# **Appendix G21**

## **Disability Access Report**

Disability Access Report

**St Philips Christian College  
Cessnock**

Figure 7 | Performing Arts Centre Concepts

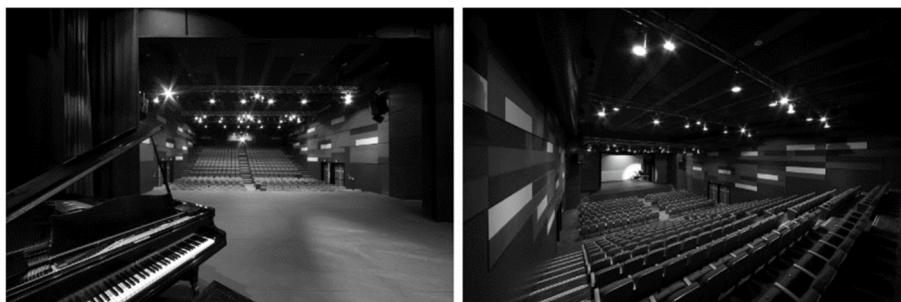
The Performance Arts Centre – Building G – is generally considered capable of compliance with current accessibility legislation as follows:

- Access is provided to and within all areas normally used by the occupants. Lift access is available between levels.
- Doorways, including the entrances, achieve circulation areas that will facilitate independent access for people with disabilities.
- Circulation areas at each level enable wheelchair turning and circulation areas.
- A unisex accessible sanitary compartment with accompanying ambulant toilets is provided within the building.

- a. Ensure the provision wheelchair seating within both the Main and Blackbox Theatres.
- b. Ensure that an accessible path of travel is provide to the stage and backstage areas.
